NOTICE TO CONTRACTORS BIDDING THIS PROJECT

Project Title: Building and Site Improvements at 6741 Downing Avenue, Bakersfield, CA

Contract No: 26016

ADDENDUM No. 5

JOB 7006	
DP AC/AY	A210A
PM GUF

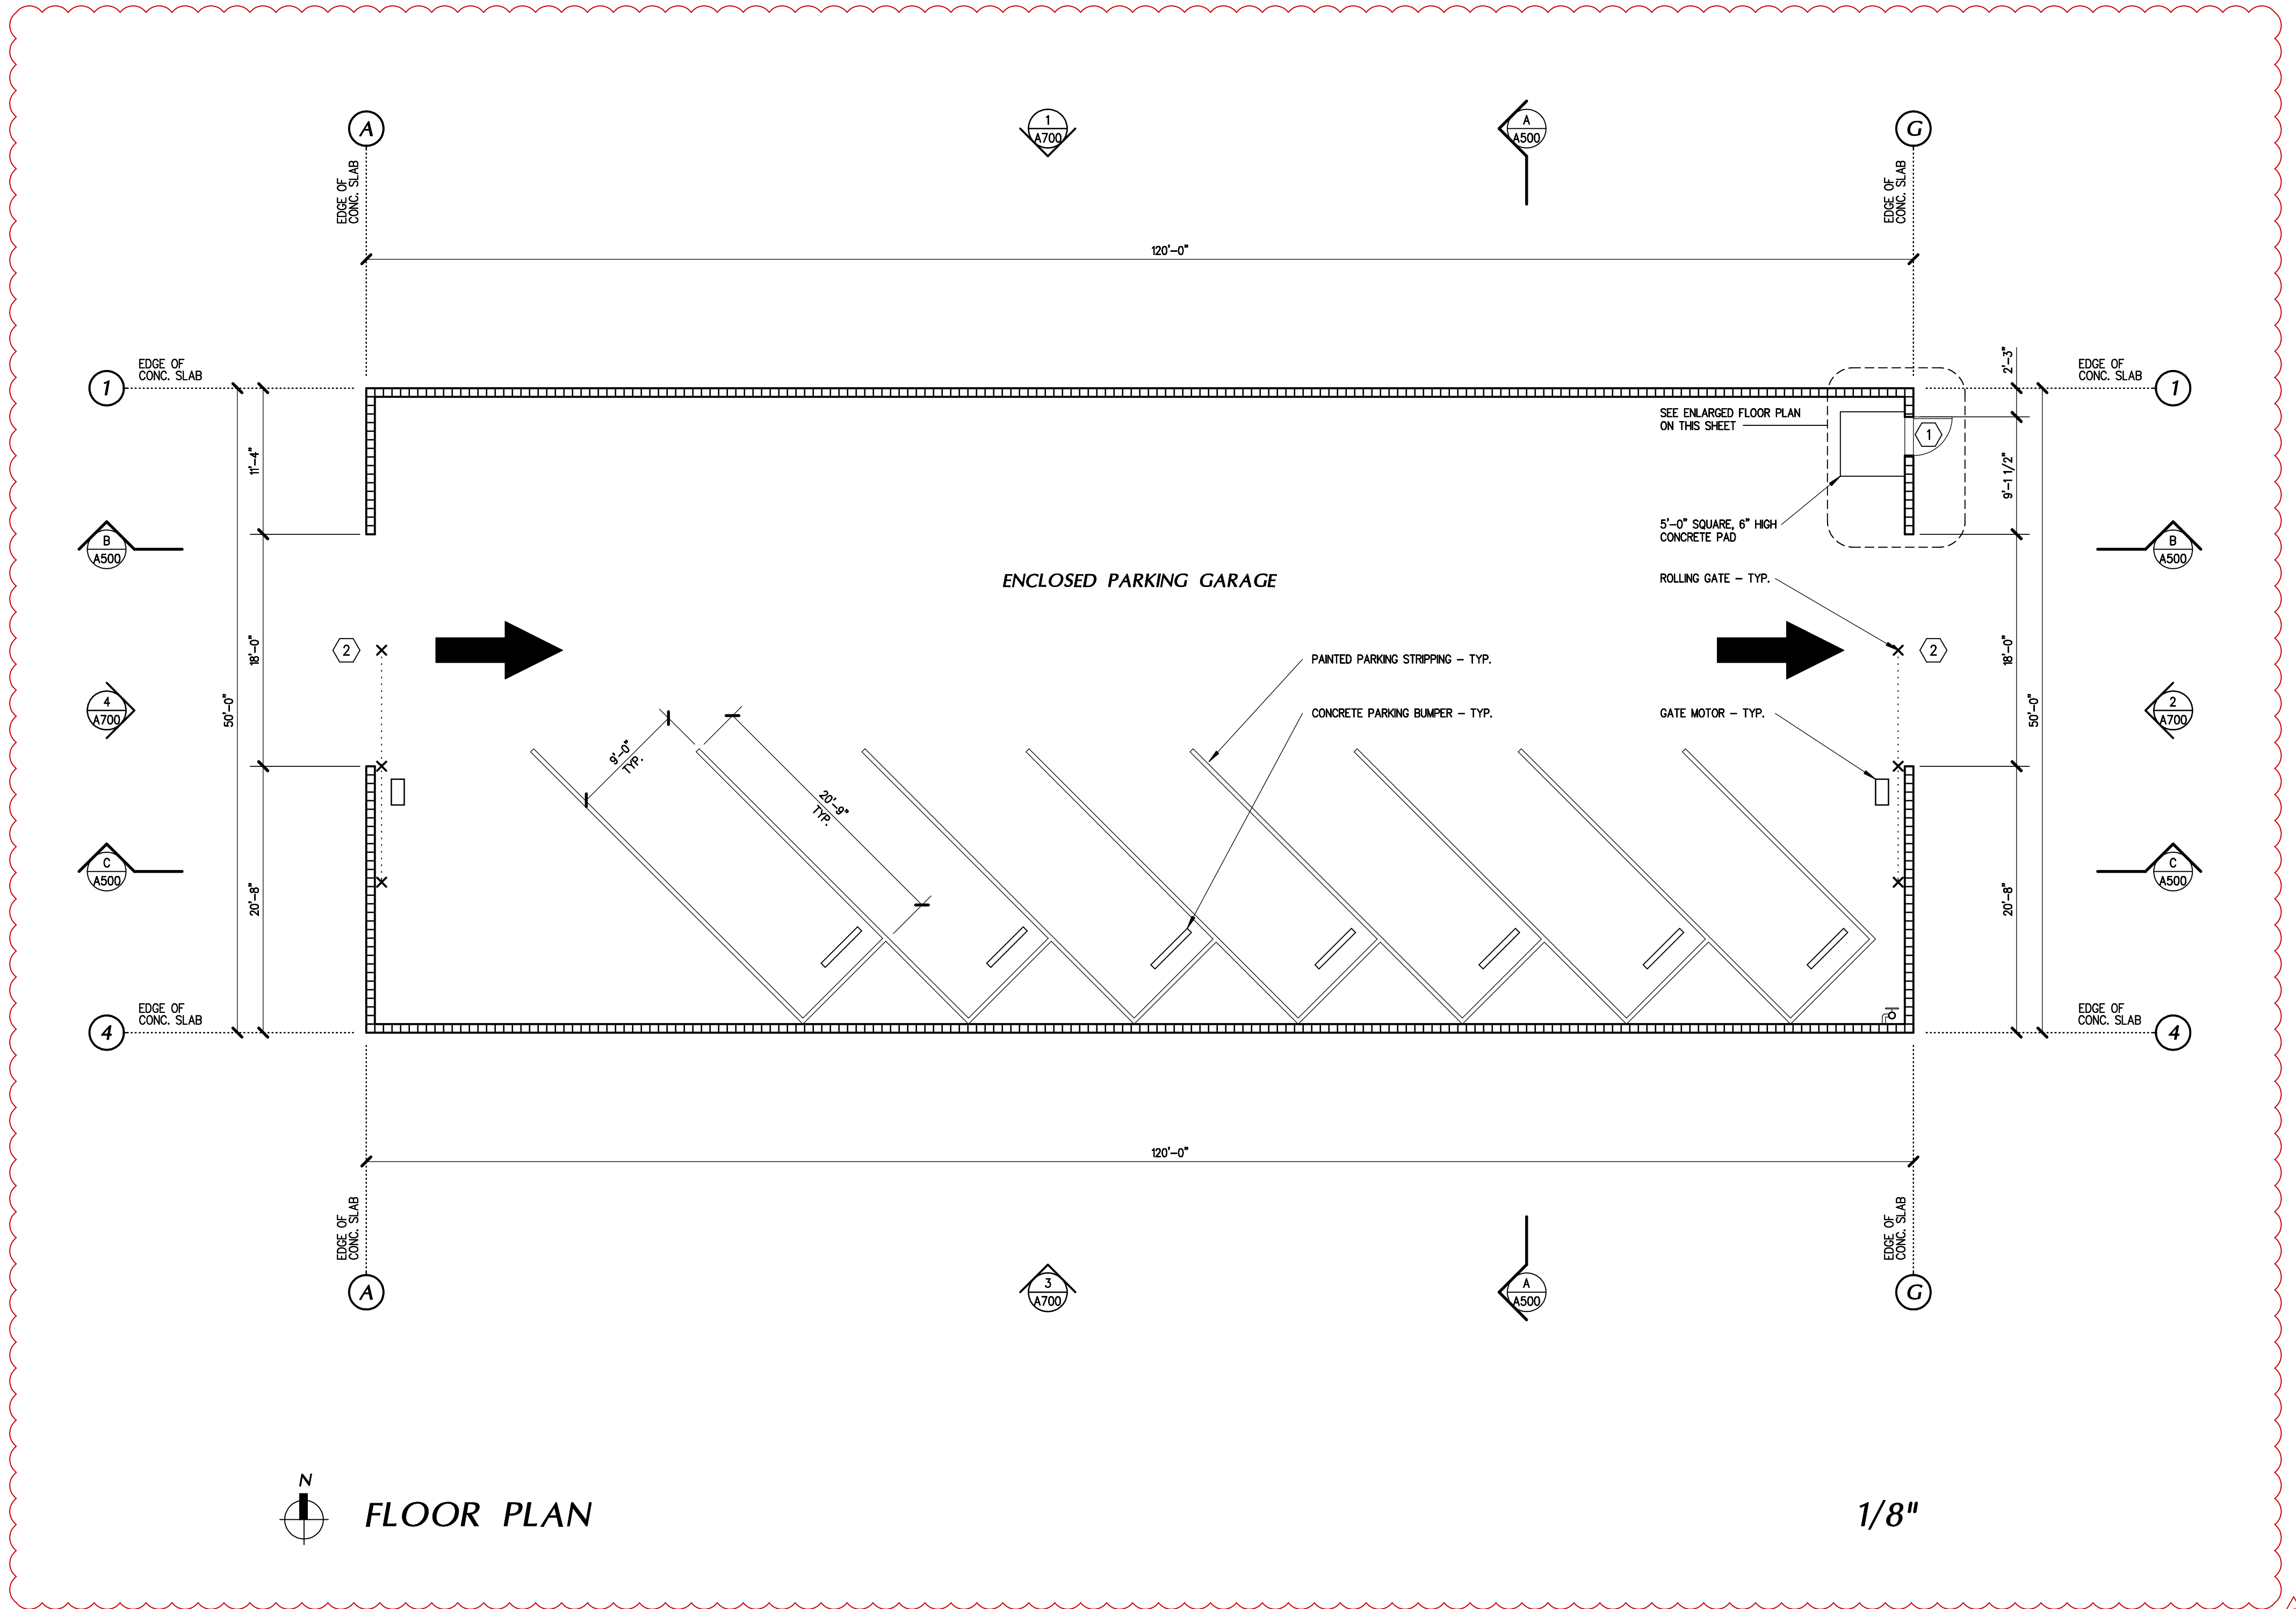
- cc. Sheet A210 has been replaced with Sheet A210A. Door hardware has been provided. Column locations have been removed. Roof shall be supported by exterior CMU walls. The revised sheet is attached to this addendum.

JOB 7005	A310A
DP AC/AY	
PM GUF

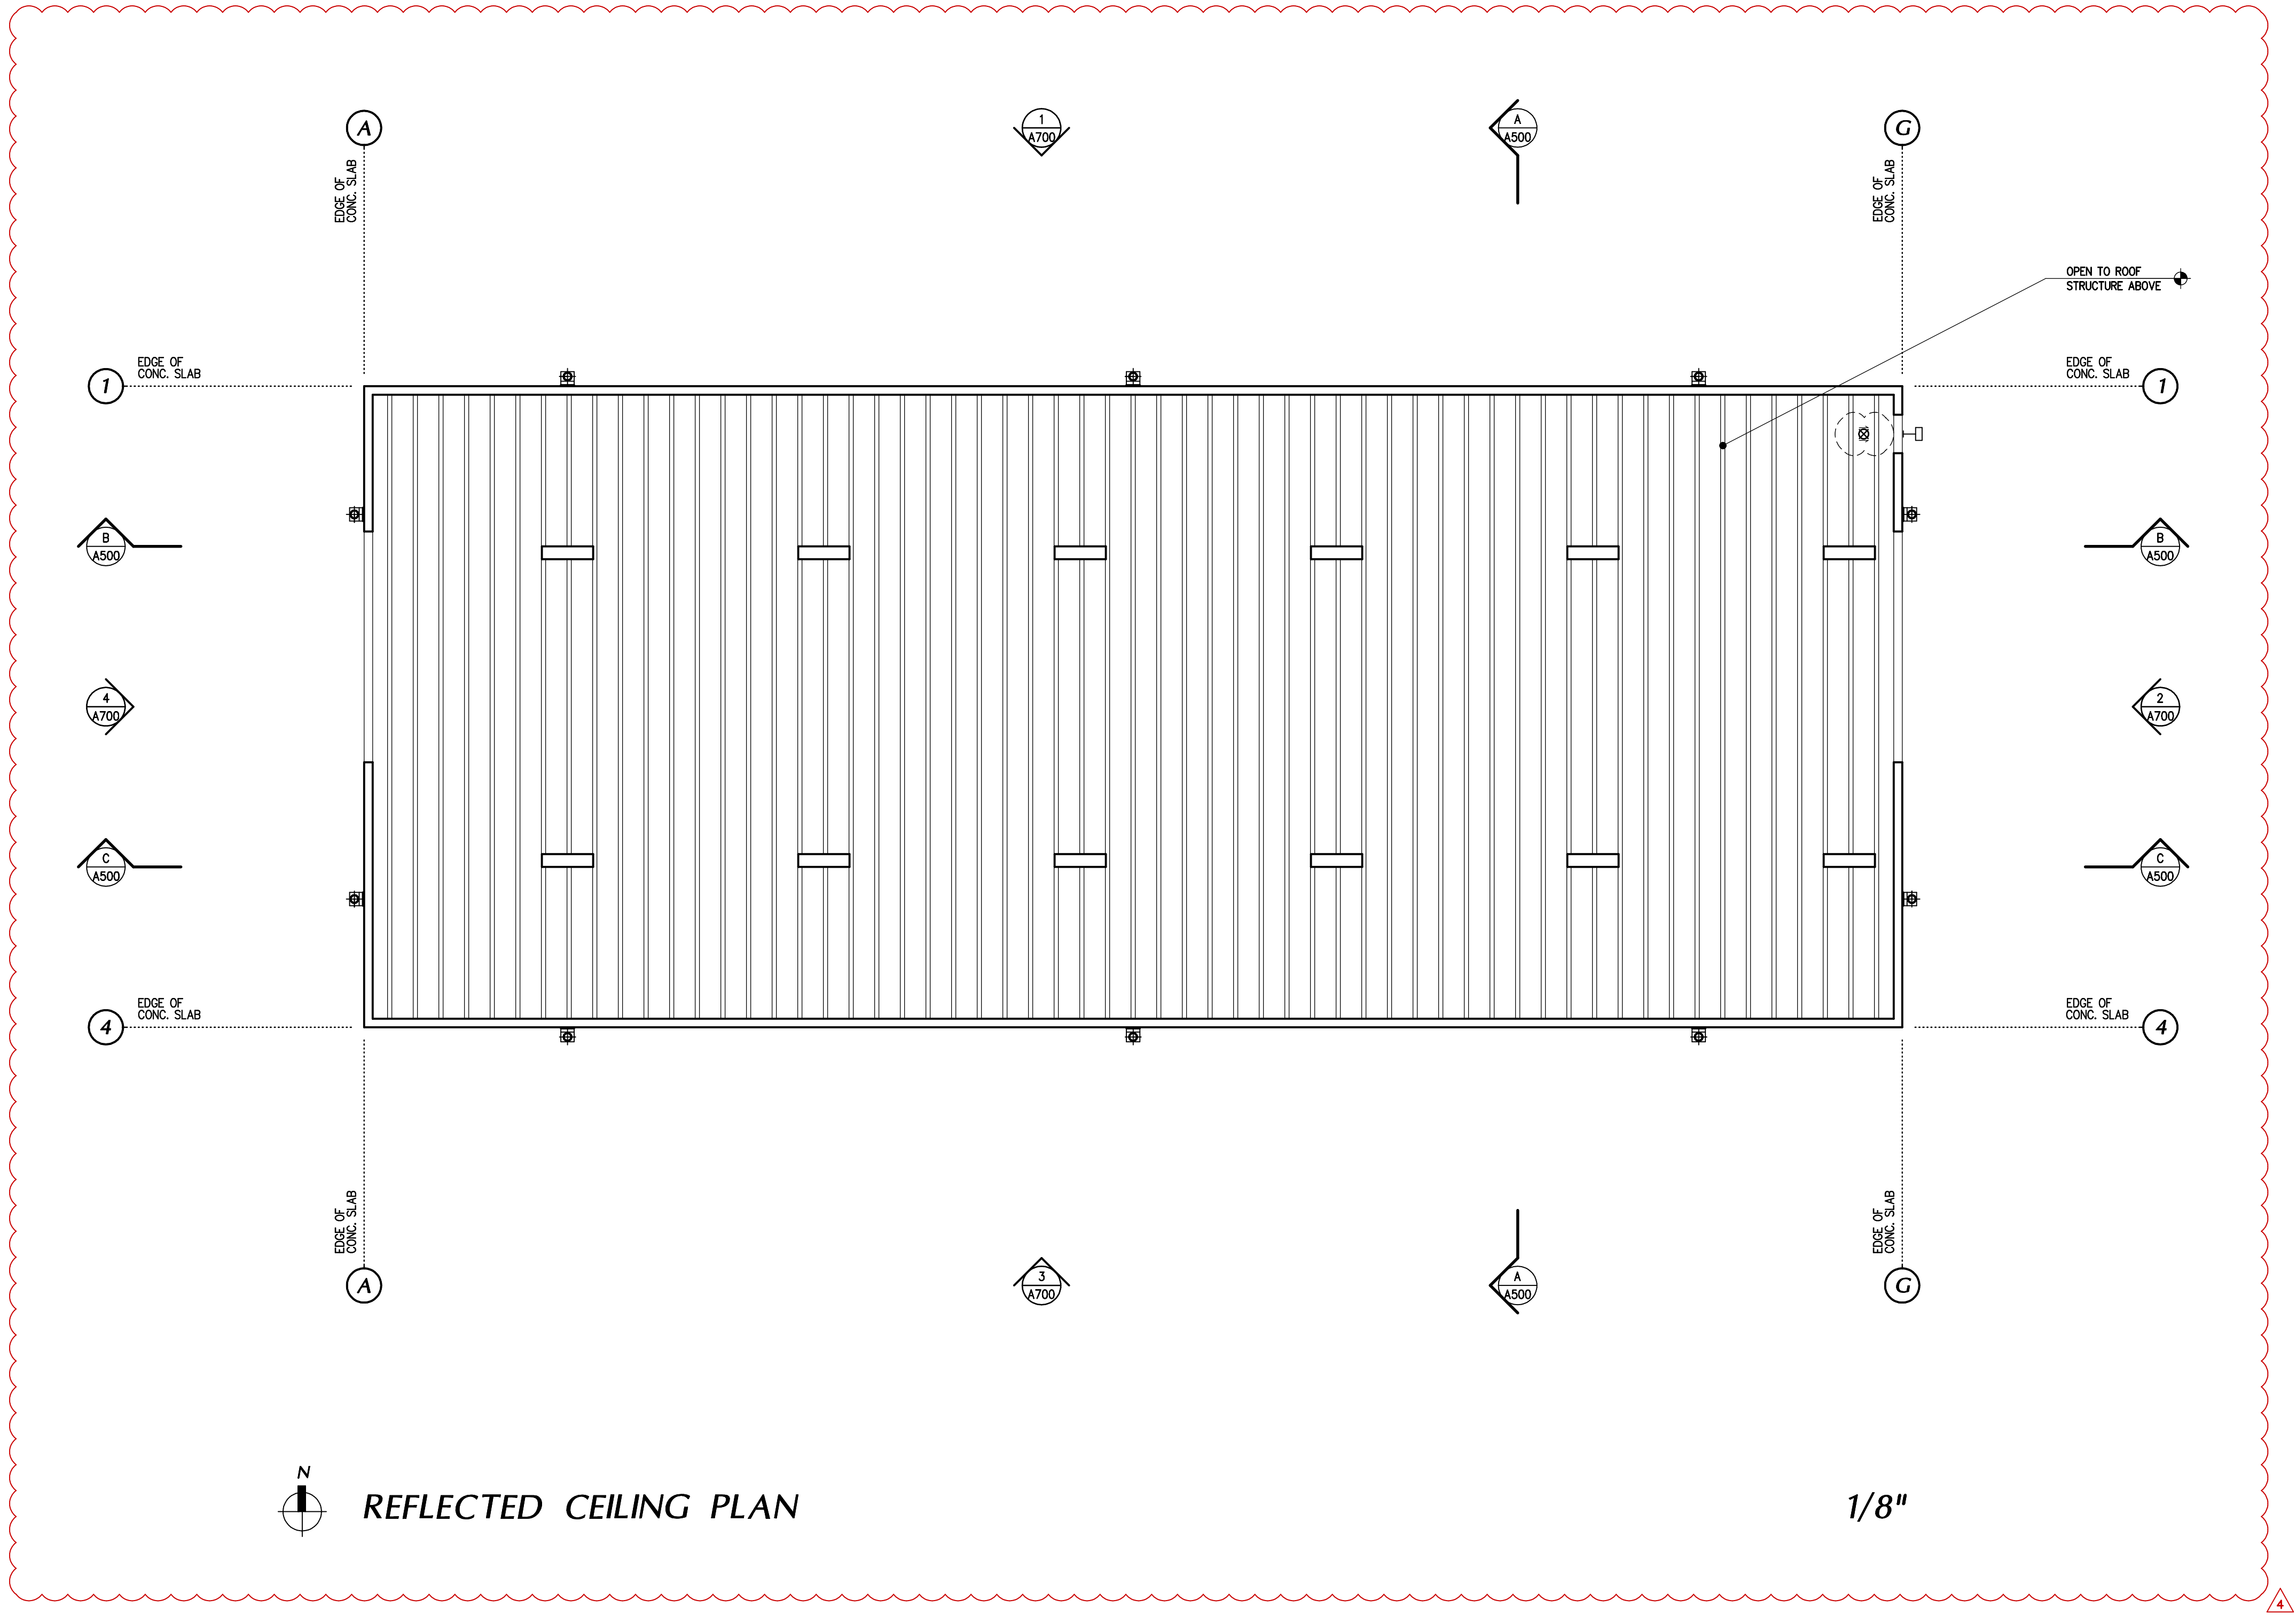
- dd. Sheet A310 has been replaced with Sheet A310A. Column locations have been removed. Roof shall be supported by exterior CMU walls. The revised sheet is attached to this addendum.

JOB 7006	
DP AC/AY	
PM GUF	A500A

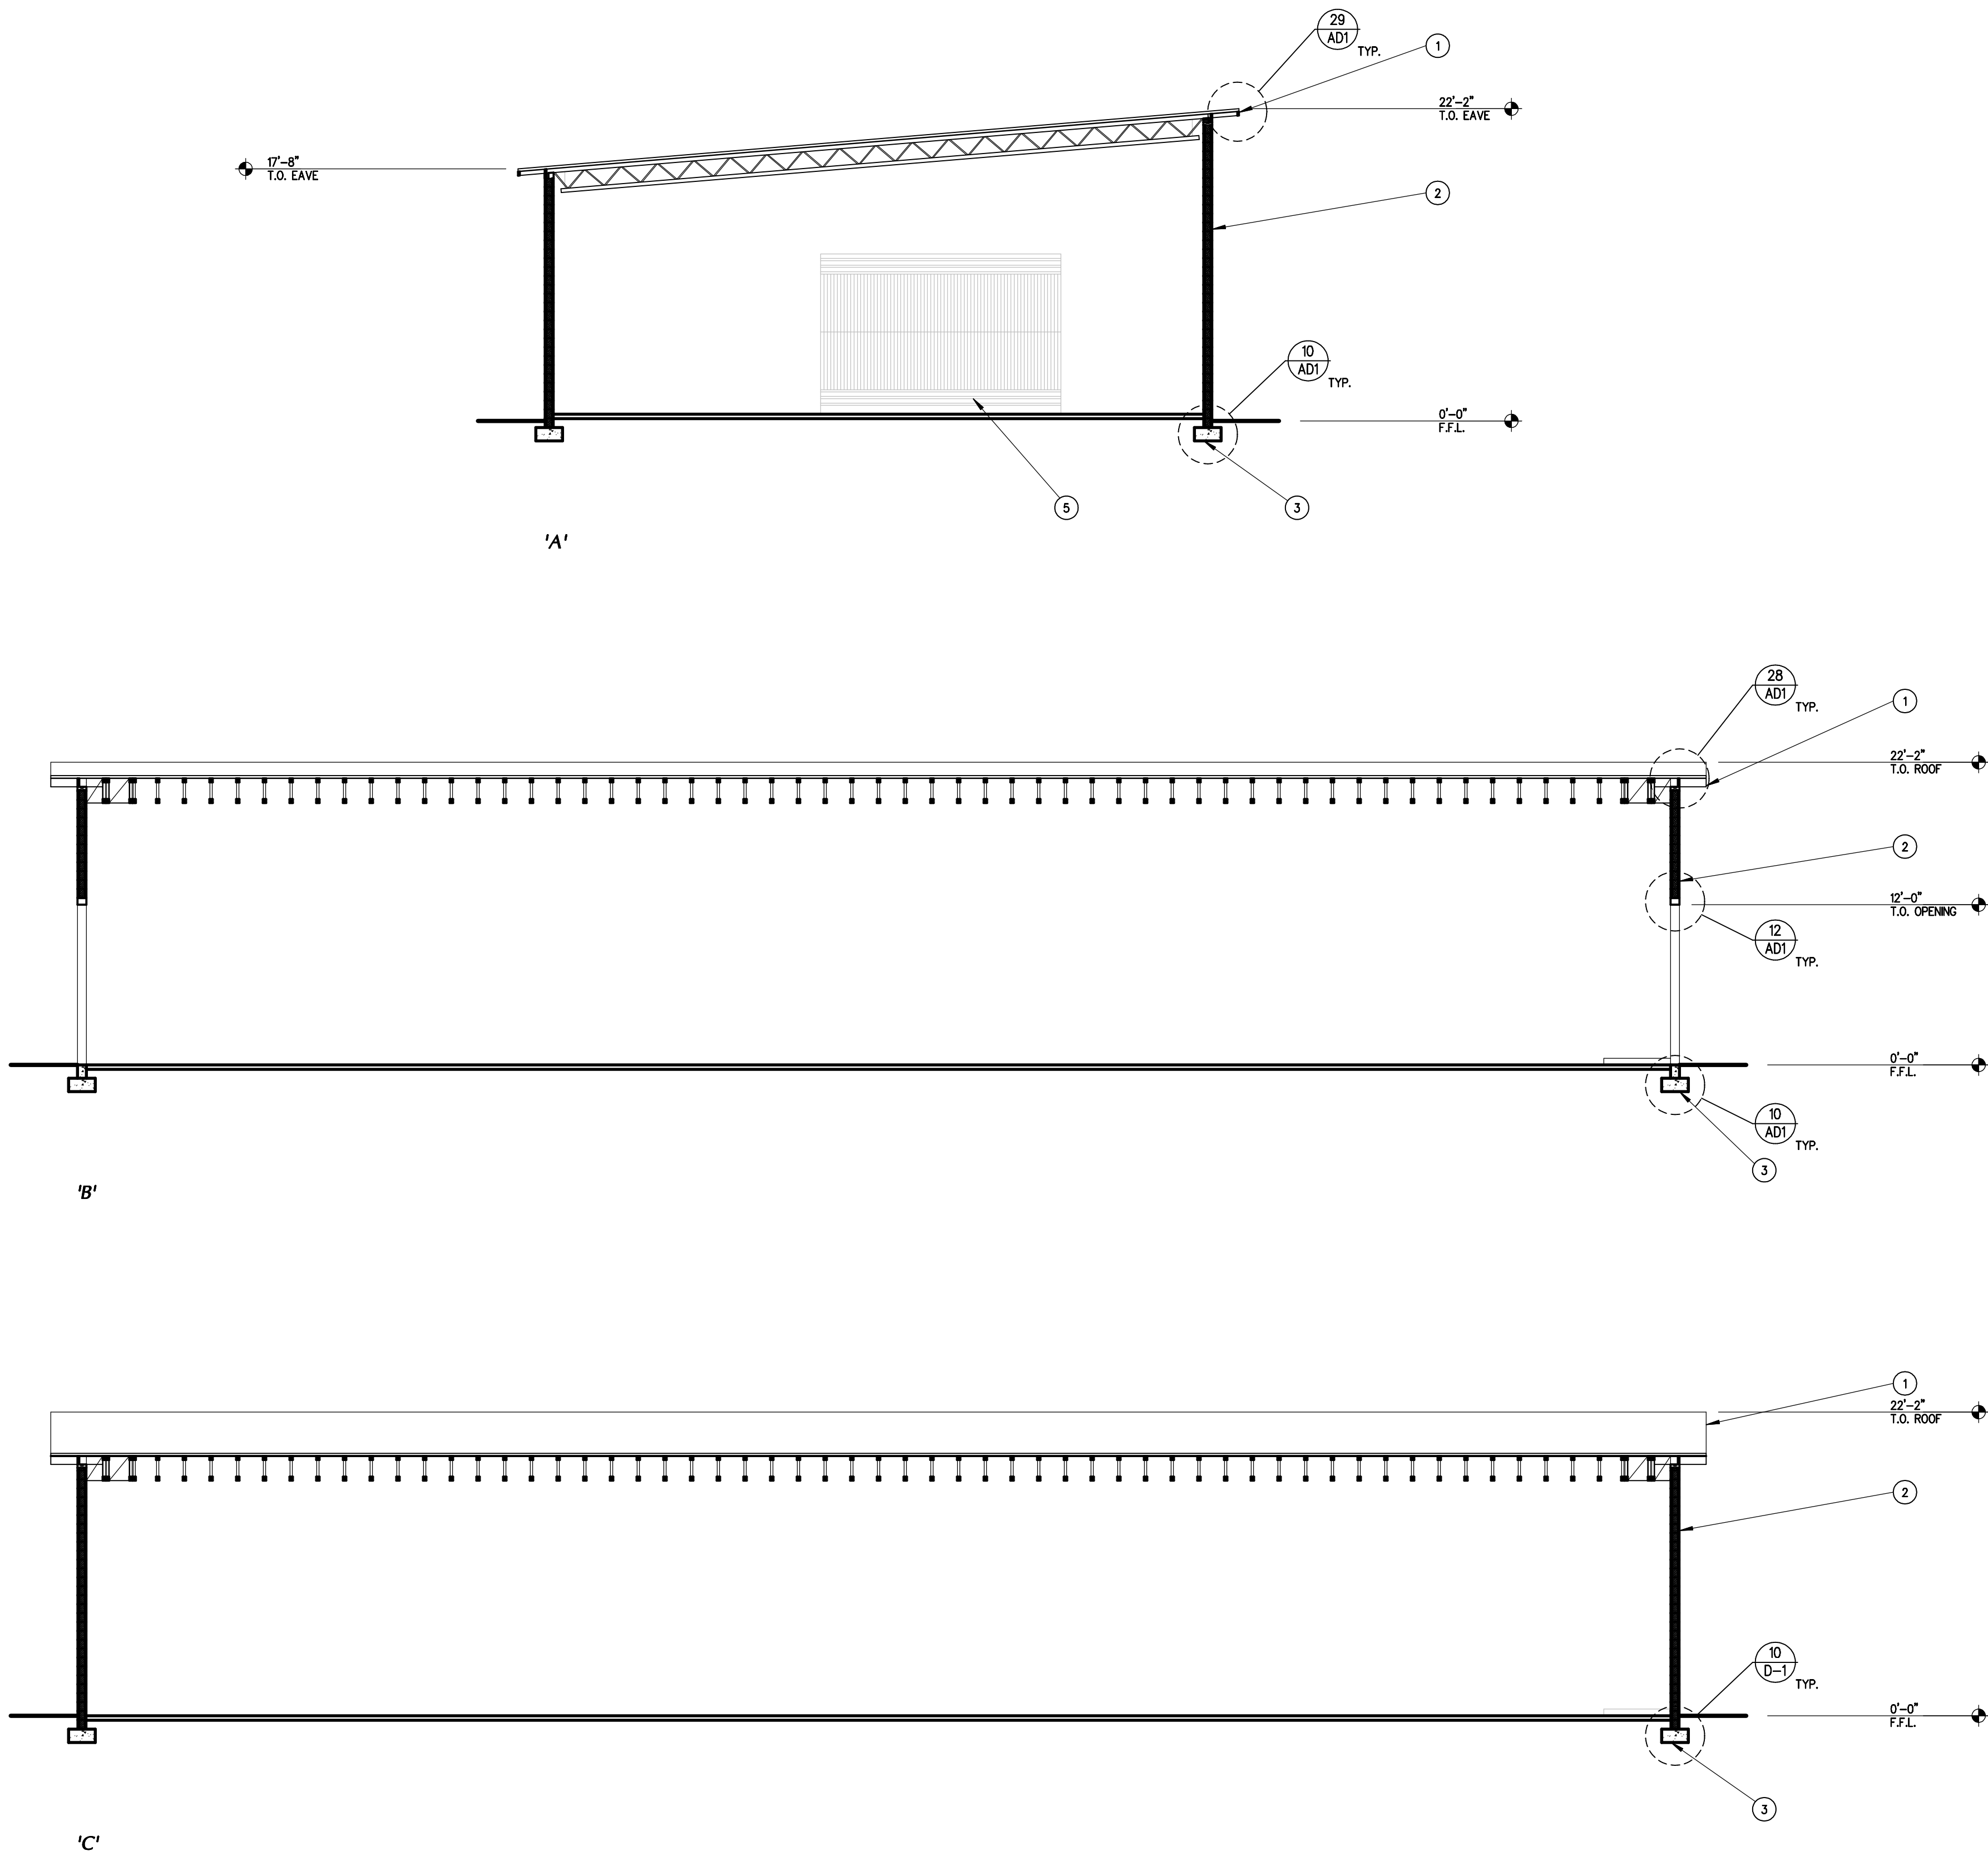
- ff. Sheet A500 has been replaced with Sheet A500A. Column locations have been removed. Roof shall be supported by exterior CMU walls. The revised sheet is attached to this addendum.
